HISTORIC AND DESIGN REVIEW COMMISSION

HDRC CASE NO: 2018-214
ADDRESS: 110 E HOUSTON ST
LEGAL DESCRIPTION: NCB 133 ALL OF BLK
ZONING: D, HE
CITY COUNCIL DIST.: 1
DISTRICT: Main/Military Plaza Historic District
APPLICANT: Jonathan Pace/Luna Middleman Architects
OWNER: Rand Building, LTD
TYPE OF WORK: Storefront system modifications, installation of stairs, an ADA ramp and signage
APPLICATION RECEIVED: April 26, 2018
60-DAY REVIEW: June 24, 2018
REQUEST:

The applicant is requesting a Certificate of Appropriateness for approval to:

SITE PLAN - PROPOSED

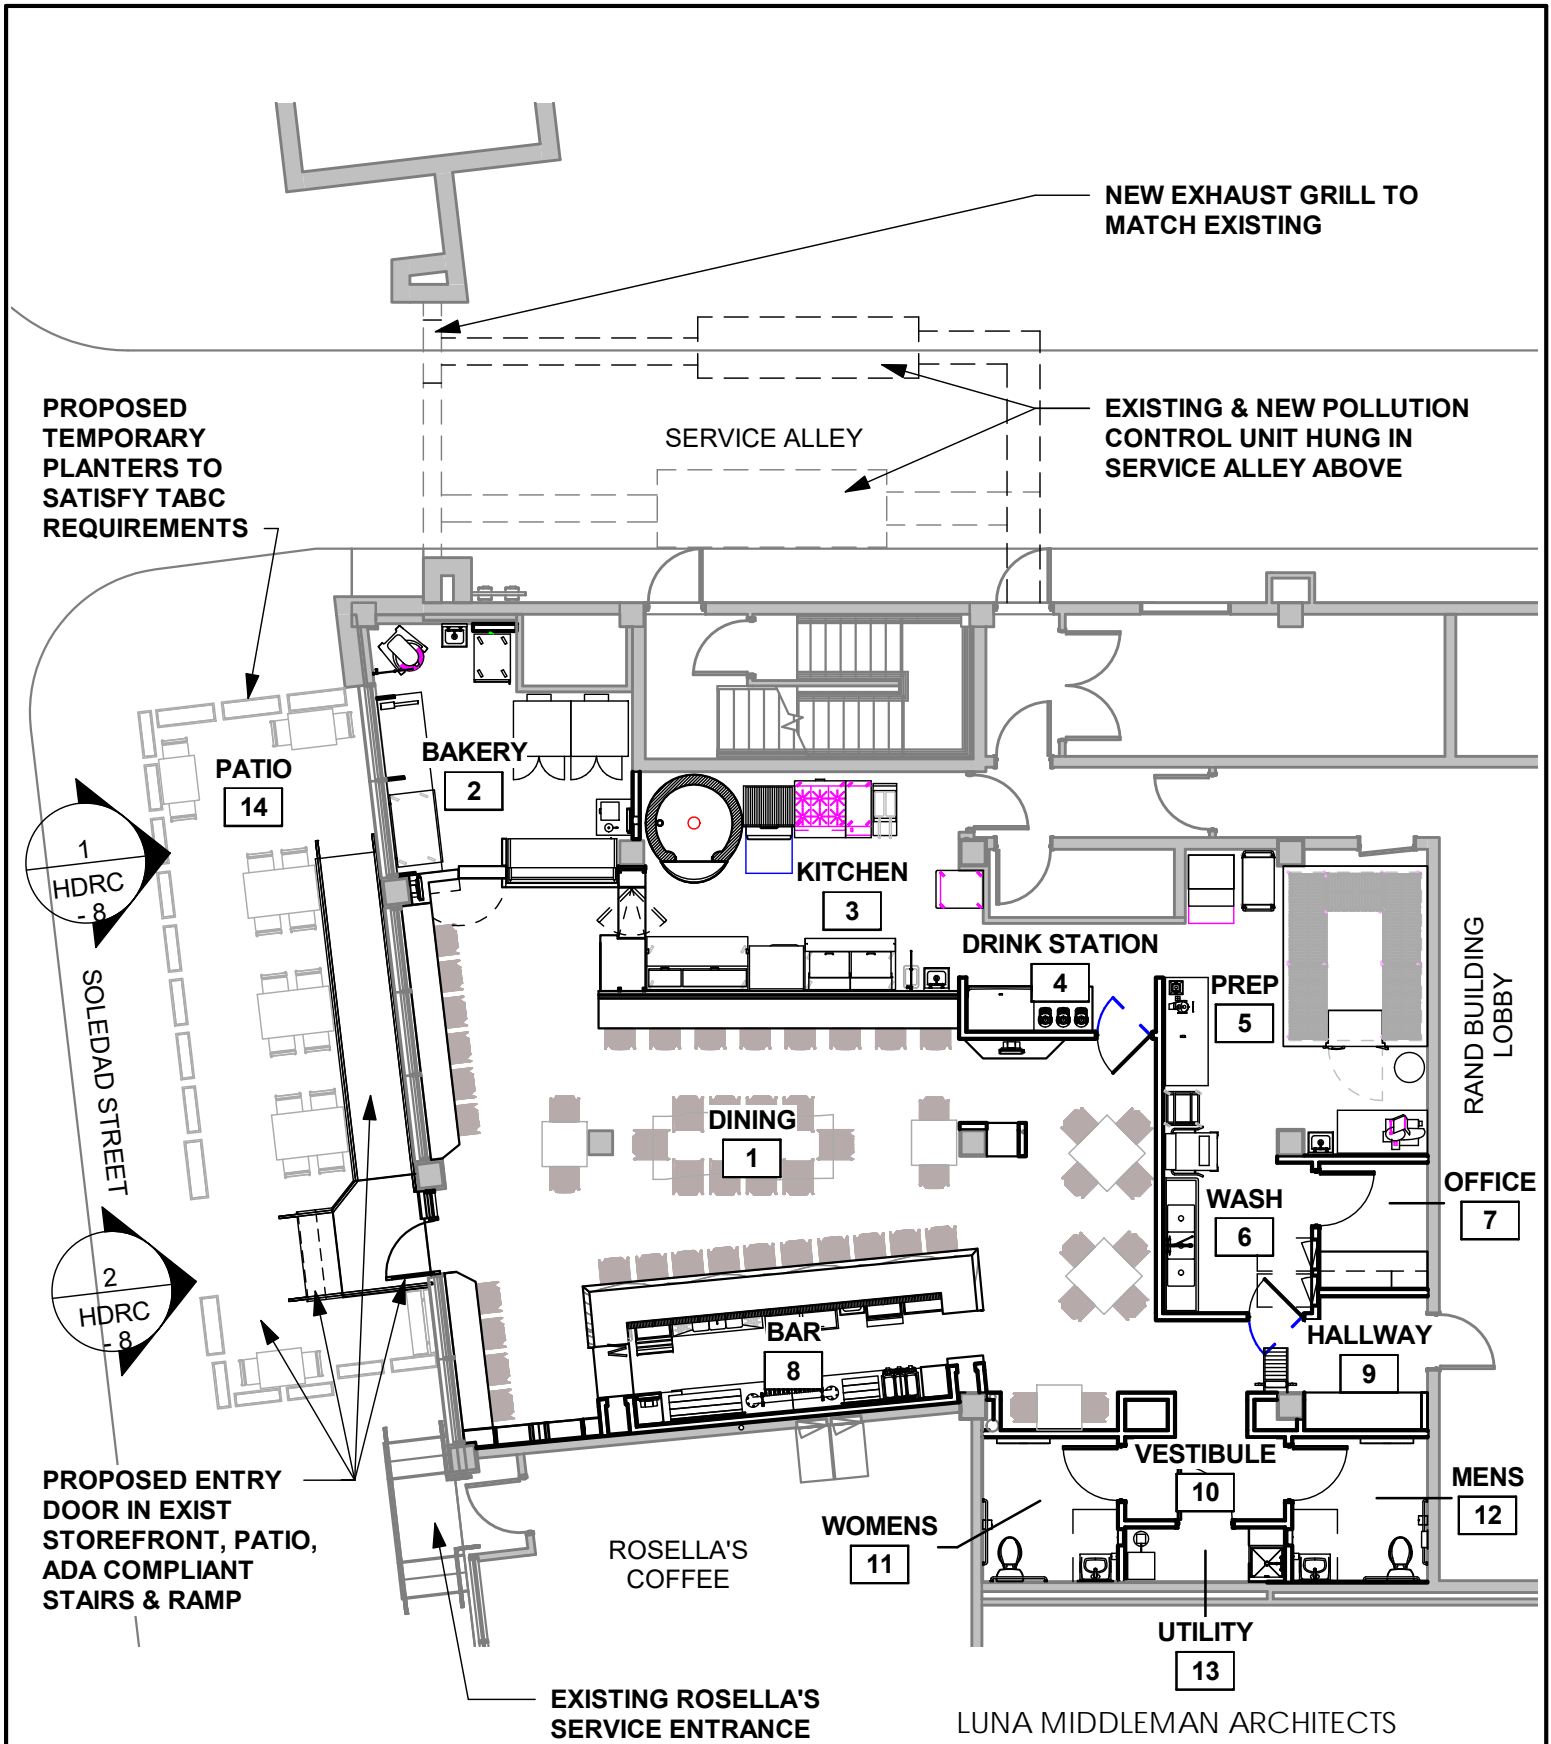
- b. ENTRY STEPS & RAMP – The applicant has proposed to install new front entry steps and an ADA compliant ramp on the Soledad elevation of the historic structure. The Guidelines for Site Elements 8. Notes that damage to the historic character of the historic structure and sidewalk should be minimized while installing ADA complaint elements. Additionally, the Guidelines for Site Elements 8 notes that ramps should be designed to be visually unobtrusive. The Soledad façade of the Rand Building is the structure’s secondary façade. Staff finds that the proposed installation will not negatively impact the architectural integrity of the structure and can be removed in the future with minimal impact to the building. Additionally, the applicant has noted that the stair, ramp and railing detail will match that of the previously installed stairs.

- d. PLANTERS & PATIO FURNITURE – The applicant has proposed to install temporary planters and patio furniture on the sidewalk adjacent to the historic façade. Staff finds this installation to be appropriate; however, the applicant should submit details on the planters and furniture that include materials and colors. Wood, metal or masonry are appropriate.

- i. That the applicant submit information regarding the proposed planters and patio furniture that includes material and color specifications.
- ii. That the storefront be protected while concrete for the ramps is poured and that a minimal space between the ramp and the building be maintained to ensure reversibility of the condition.

FRONT ELEVATION - OVERALL

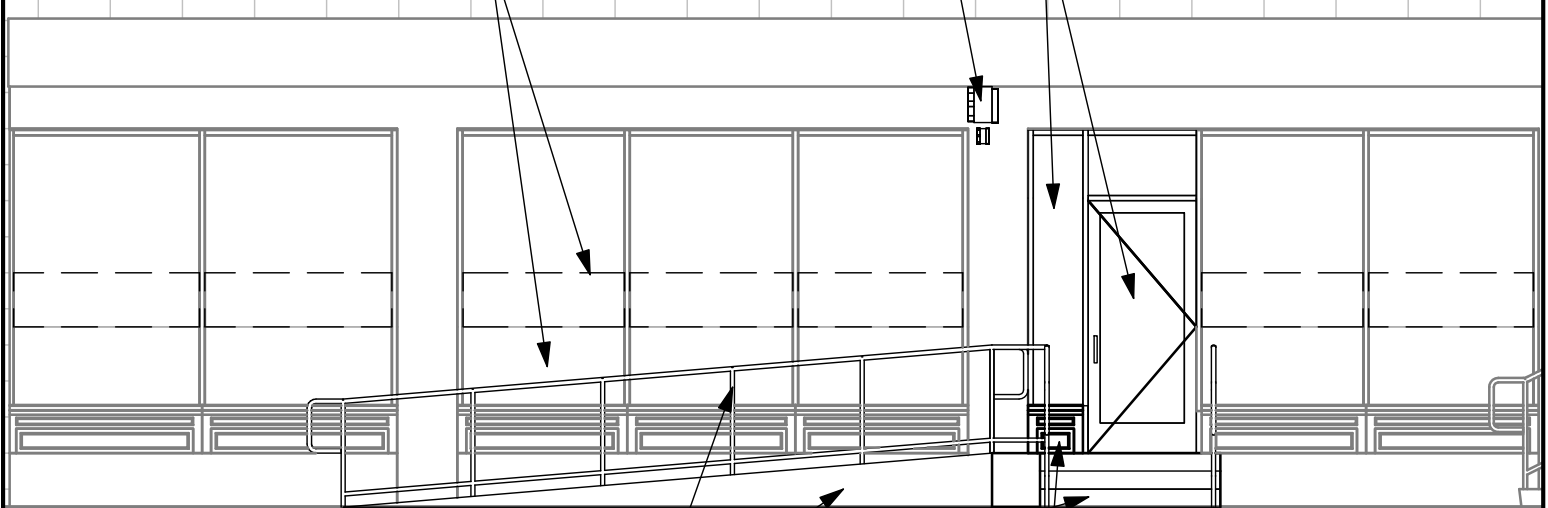
- c. NEW ENTRY DOOR – In addition to the proposed stairs and ADA ramp, the applicant has proposed to install a new door. The applicant has noted that the proposed door and modified storefront system will match the existing. Staff finds this to be appropriate. As noted in finding b, this façade is the secondary façade of the structure and the proposed installation will not negatively impact the architectural integrity of the structure.

- e. SIGNAGE – The applicant has noted location for signage that include a blade sign to be hung from the existing canopy and window signage to be located at the location of the existing modesty panels. The applicant has noted that the total square footage of the proposed blade sign will not exceed fifty (50) square feet total, including both sides, and that the total square footage of the proposed window signage will not exceed fifty (50) square feet total. The applicant has noted that the signage package is still being finalized. Generally, staff finds the location of the proposed signage to be appropriate. However, as proposed, the sign is not scaled in proportion with the canopy an should be reduced in size.

- i. That the proposed blade sign does not exceed to the face of the existing canopy and be reduced in overall size.
- ii. That the proposed sign feature halo or indirect lighting and be construction of metal.
- iii. That the proposed window clings be of a simple design and feature no more than three colors.
